EMERGENCY DIESEL GENERATOR SERVICES
FLOW DIAGRAM

DMG. NO. 302-351 SHEET REV. N/A 21

TMI-1 SCALE: NONE

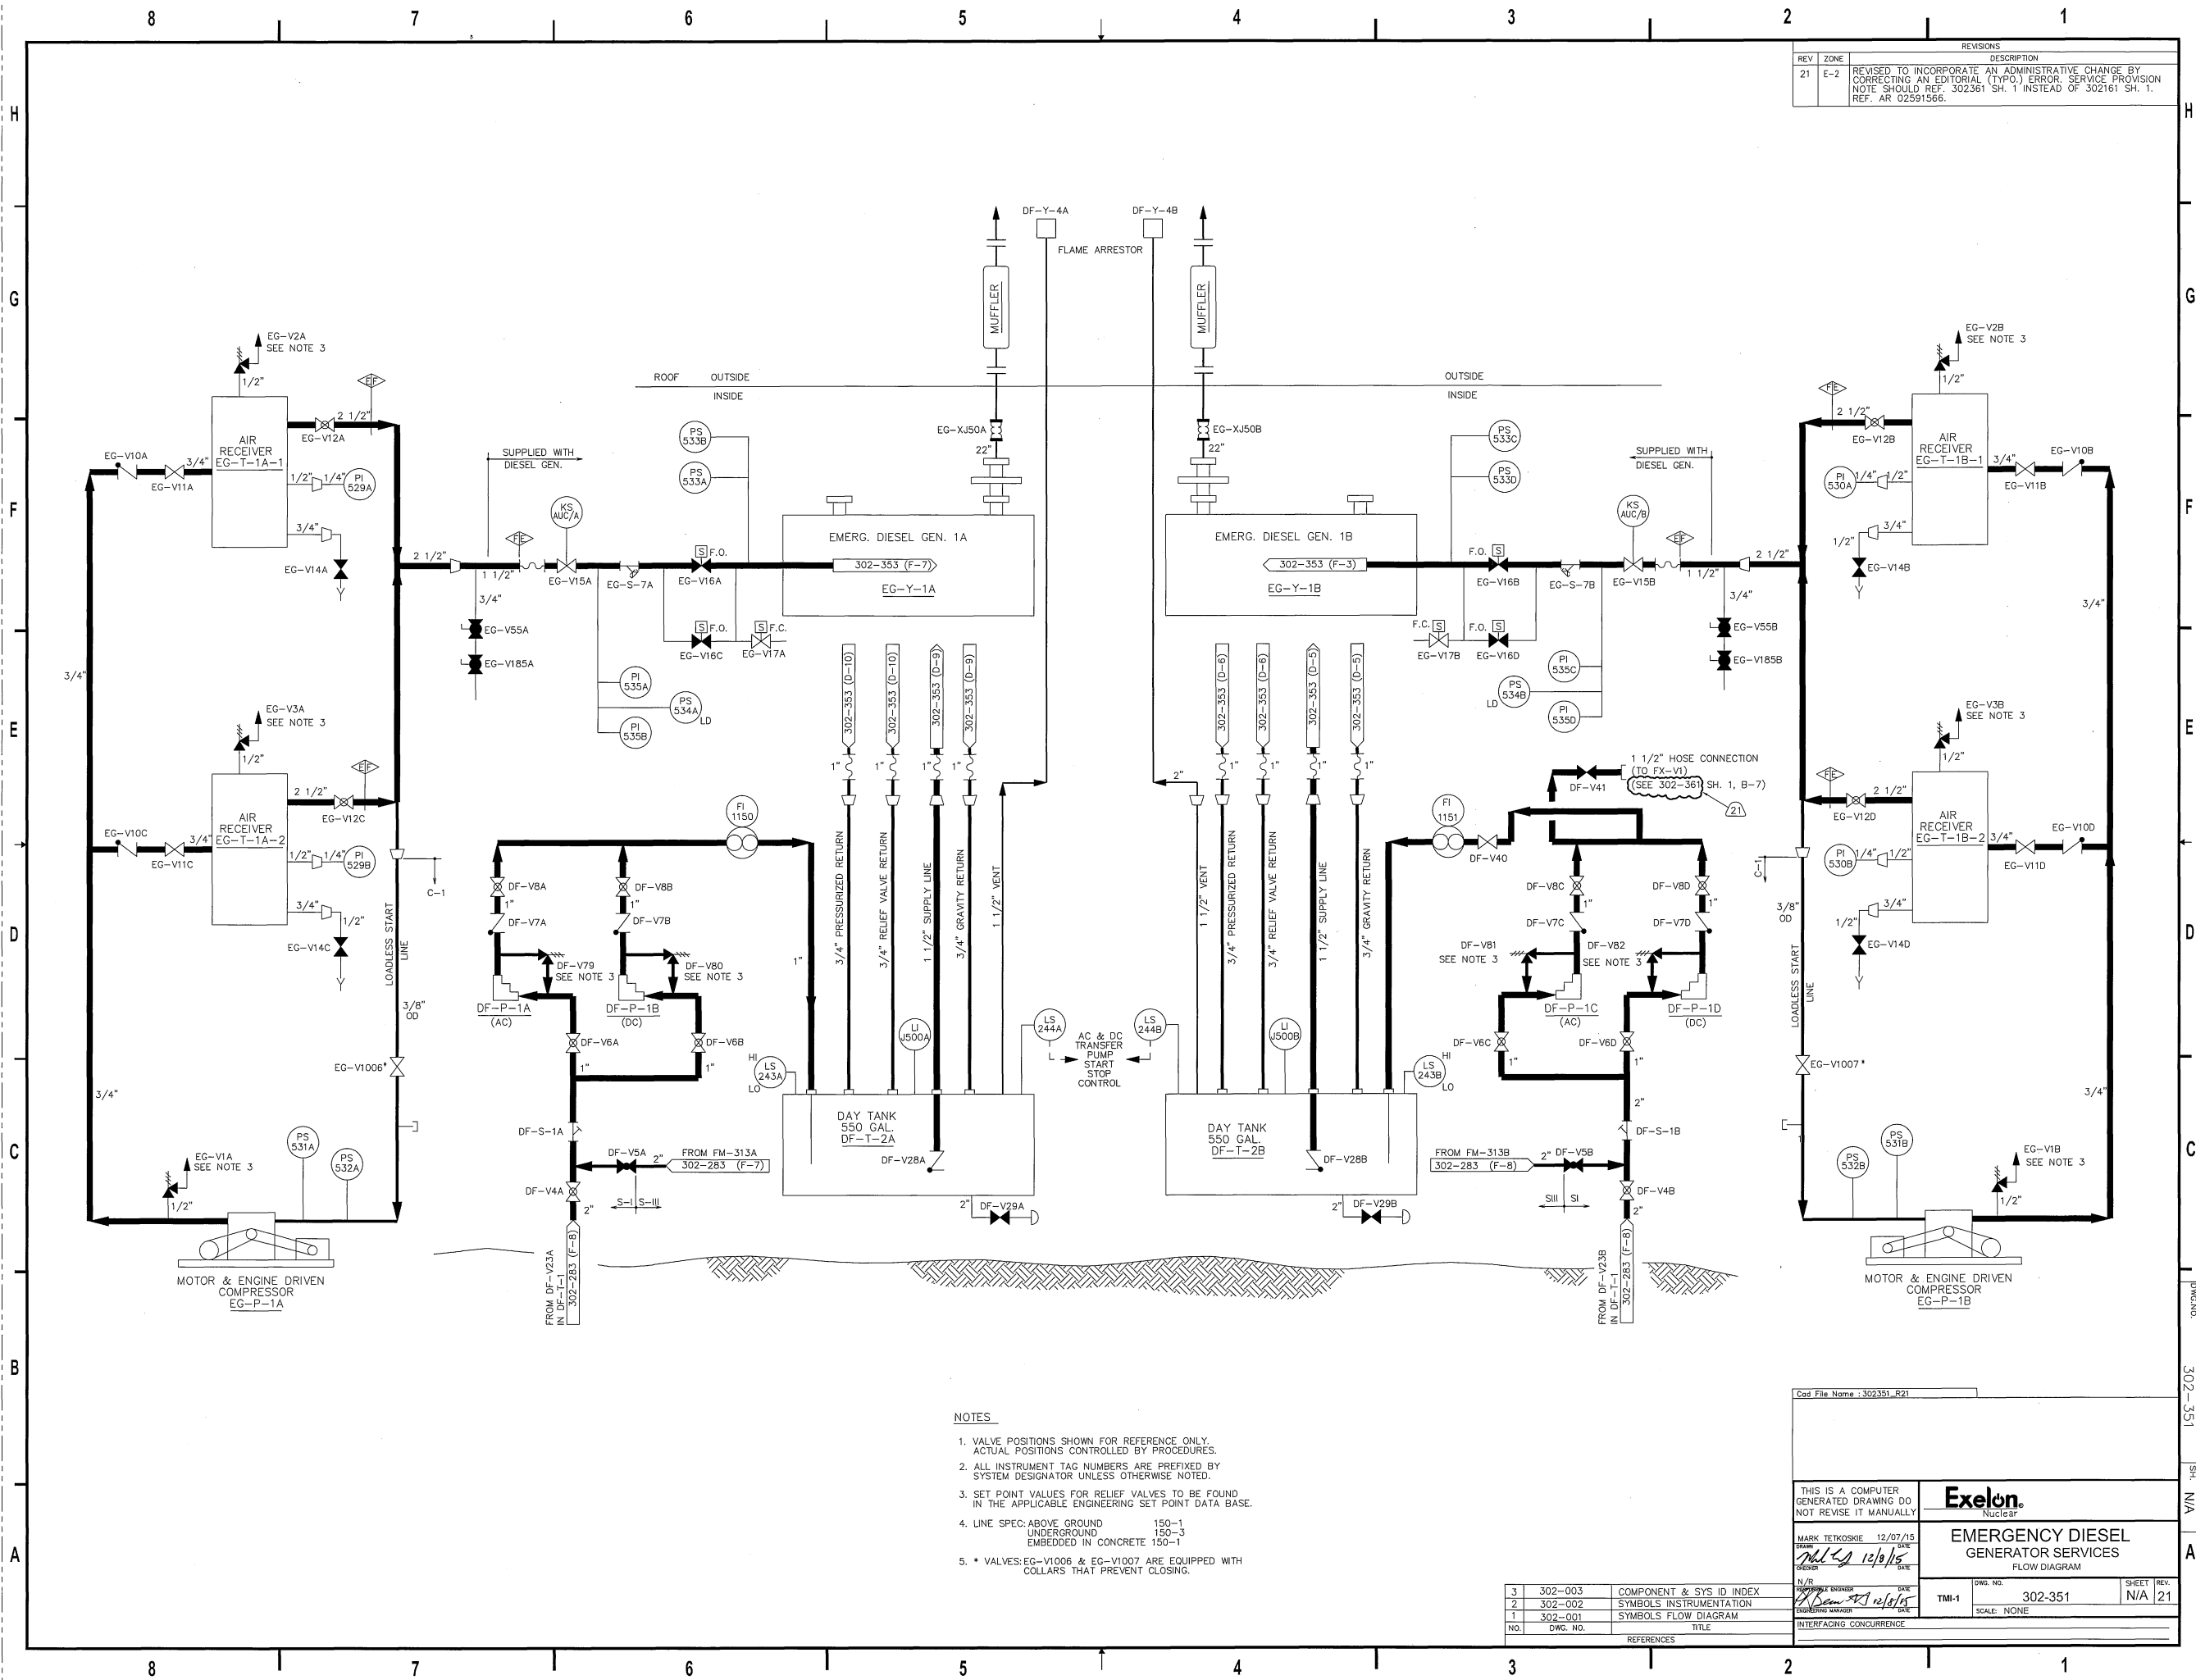
REV	ZONE	DESCRIPTION
21	E-2	REVISED TO INCORPORATE AN ADMINISTRATIVE CHANGE BY CORRECTING AN EDITORIAL (TYPO) ERROR. SERVICE PROVISION NOTE SHOULD REF. 302361 SH. 1 INSTEAD OF 302161 SH. 1. REF. AR 02591566.
